PLANNING AND DEVELOPMENT SERVICES

TO:	Municipal Planning Commission Subdivision Authority	DIVISION: 8
DATE:	June 23, 2021	APPLICATION: PL20210013
FILE:	05629083	
SUBJECT:	Subdivision Item – Creation of One Residential Lot

APPLICATION: To create a ± 1.62 hectare (± 4.00 acre) parcel (Lot 1) with a ± 3.49 hectare (± 8.63 acre) remainder (Lot 2).

TENTATIVE PLAN

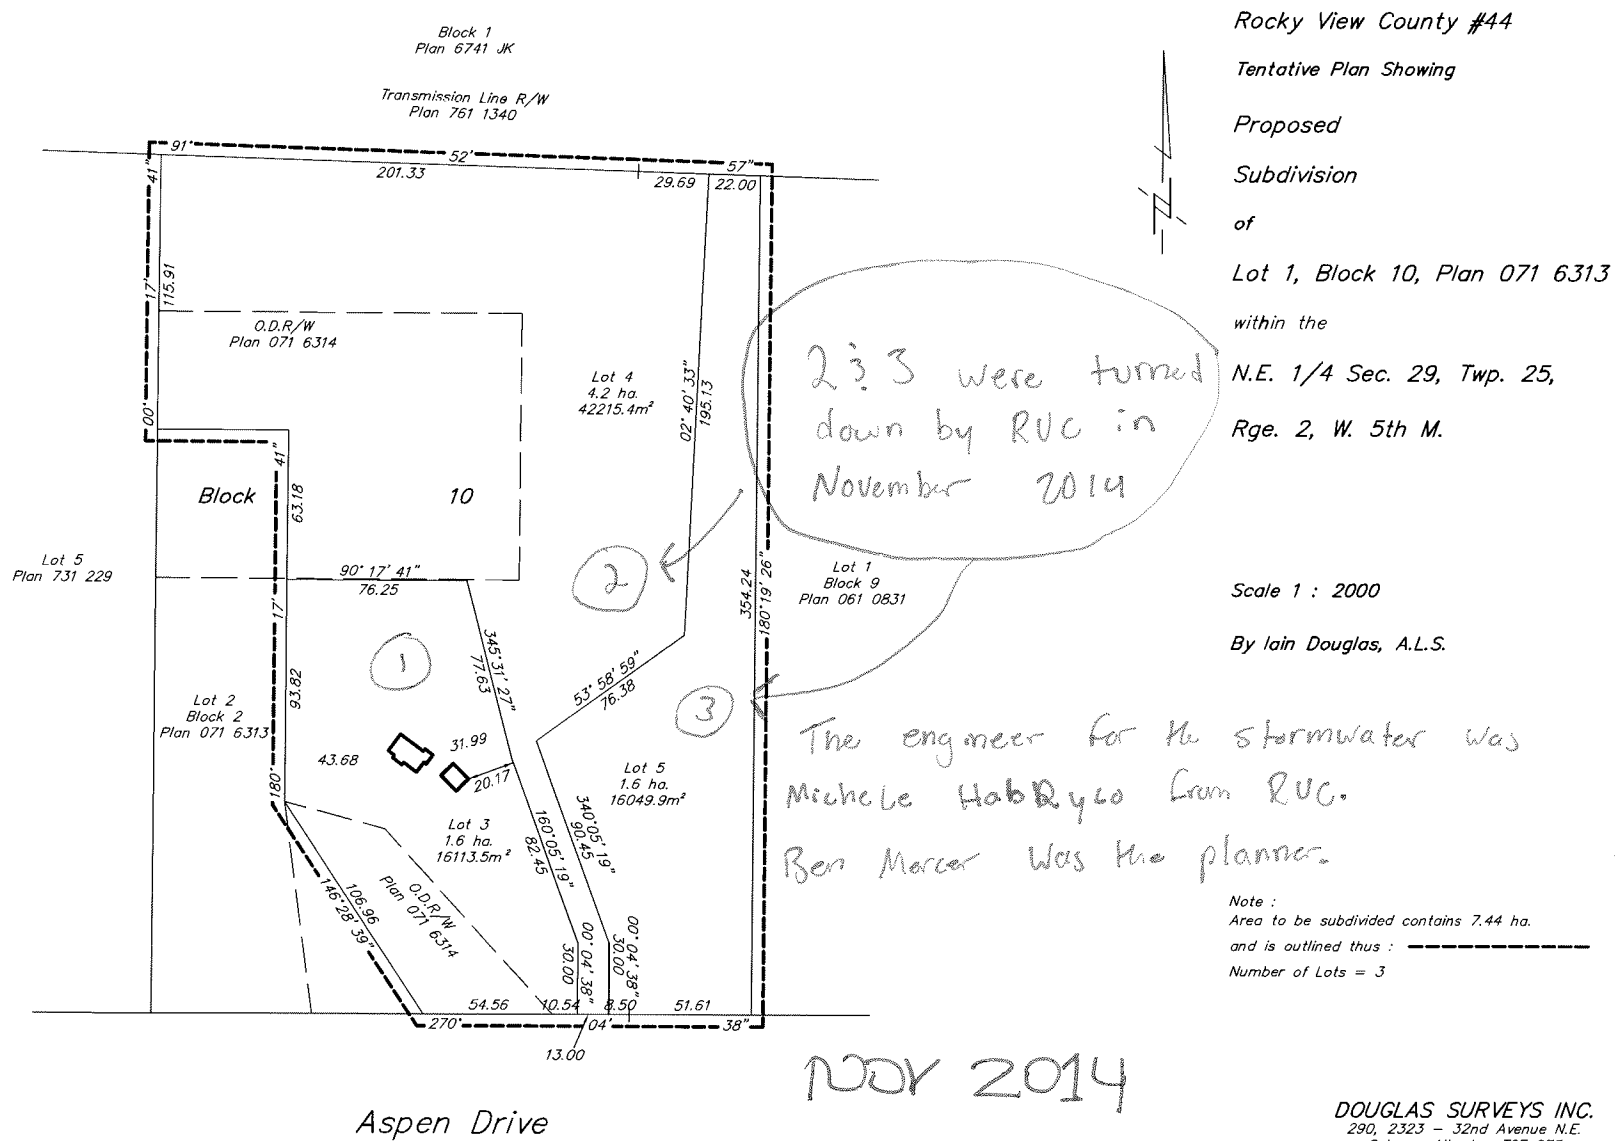
Existing approach to be upgraded to mutual standard, including ROW Plan and easement agreement

THIS PASSED 1 EXTRA LOT

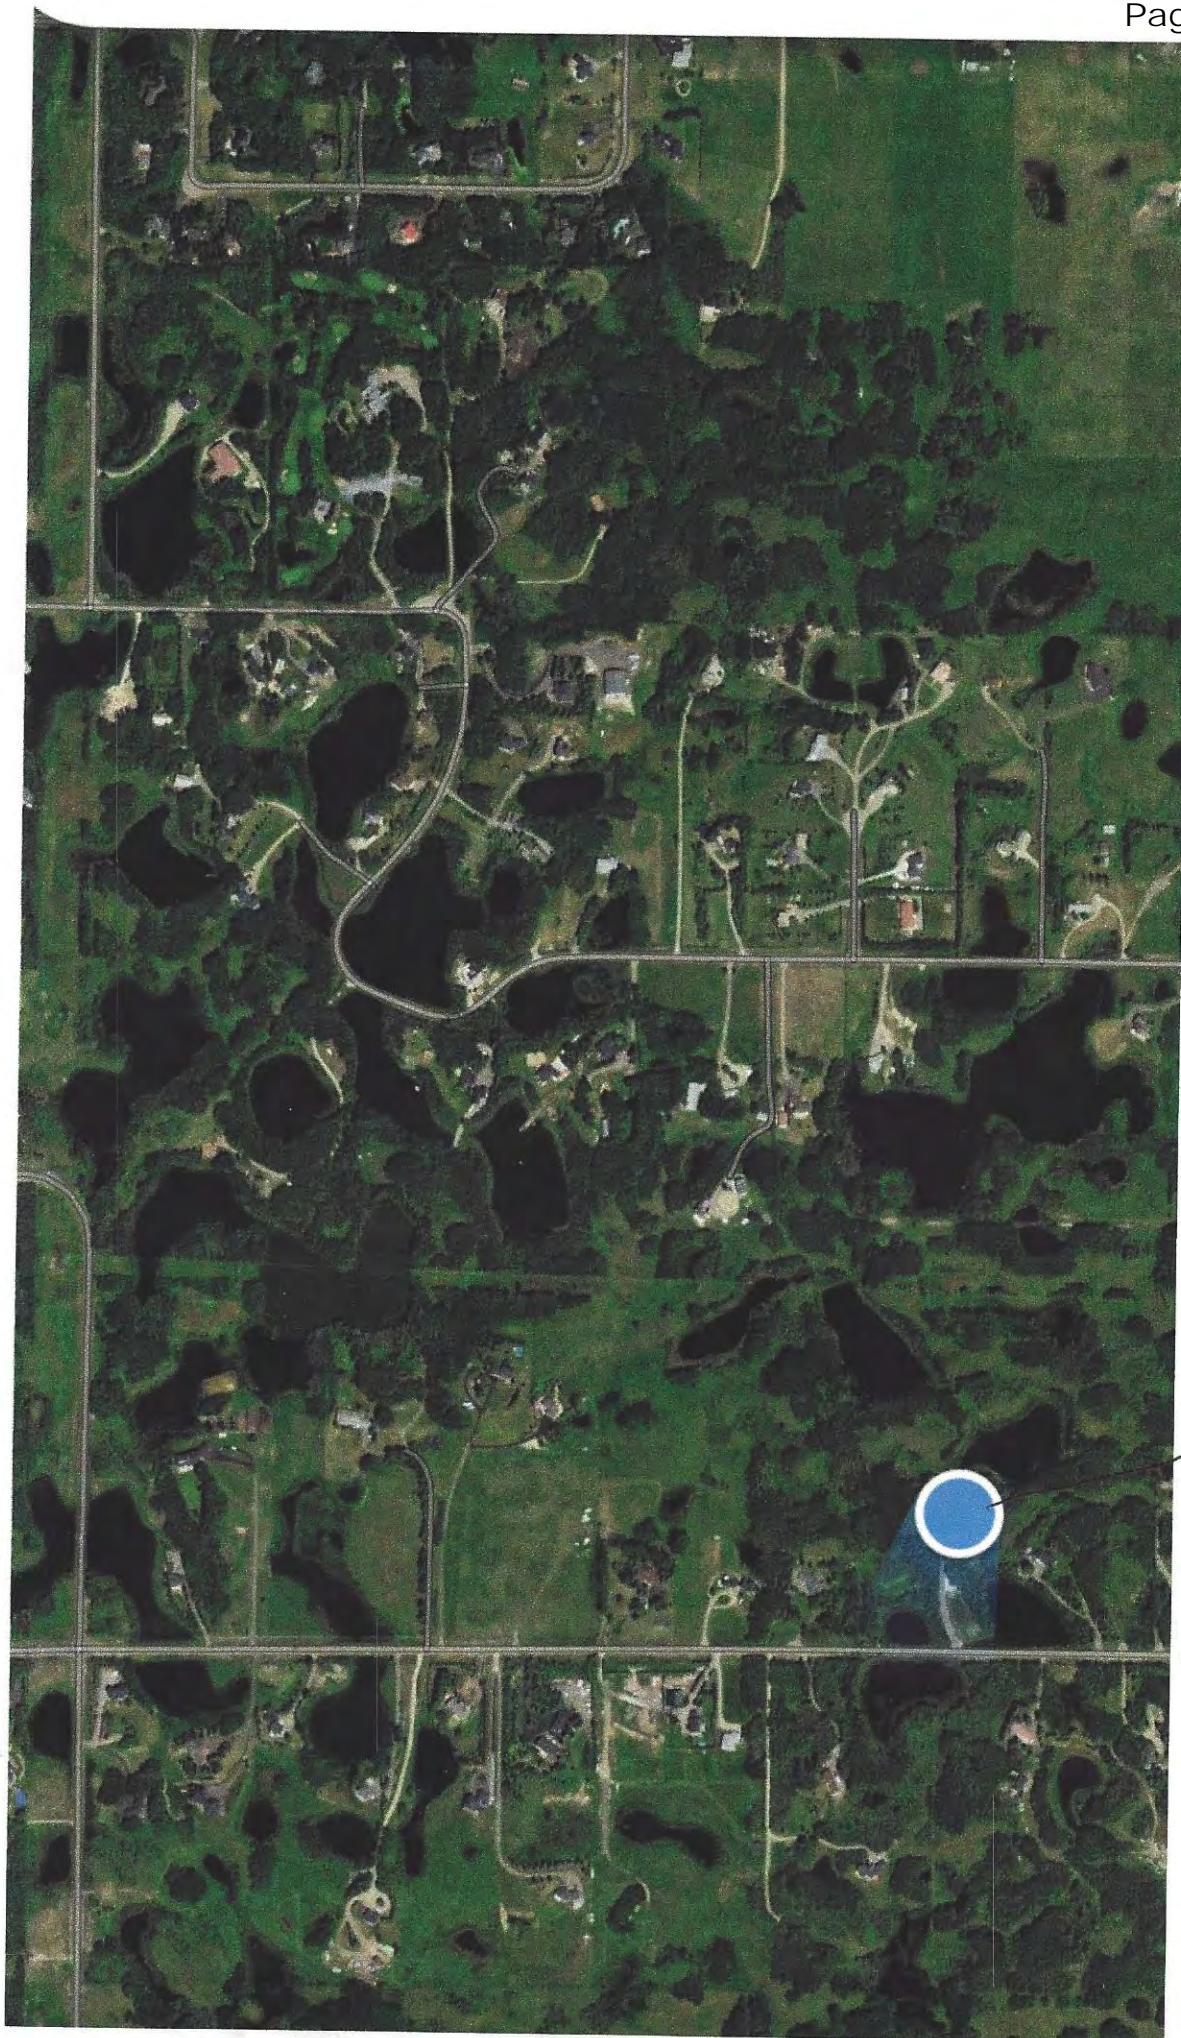
Storm water drainage especially after a storm is a major issue for residents along Aspen Drive. RVC county has conducted emergency pumping from ponds along Aspen Drive. In this situation, my property at 24100 Aspen Dr. has ponds in front and back of my house. These ponds drain to the east through 24066, 24050, and floods the property at 24050 and 24042. A subdivision of property would result in an increase in water runoff due roads and removal of trees without a proper storm water drainage plan for this subdivision.

- 1. Until the storm water planning, and drainage issues are resolved there should be no approval for this subdivision.
- 2. The Rocky View County needs an approved (with input from landowners) conceptual scheme, a site development plan and a master storm water drainage plan for the affected areas. In the surrounding area between and Meadows Drive and Aspen Drive there numerous 10-20 acreages. The County must develop a comprehensive storm water management plan that would be effective for the entire area for any subdivision to proceed. Otherwise, this area could end up like the Meadows Drive flood zone.
- 3. In rural areas like Rocky View County, some insurance companies are not providing overland flooding insurance coverage to residents. This could have unintended consequences for property owners, developers, and Rocky View County.
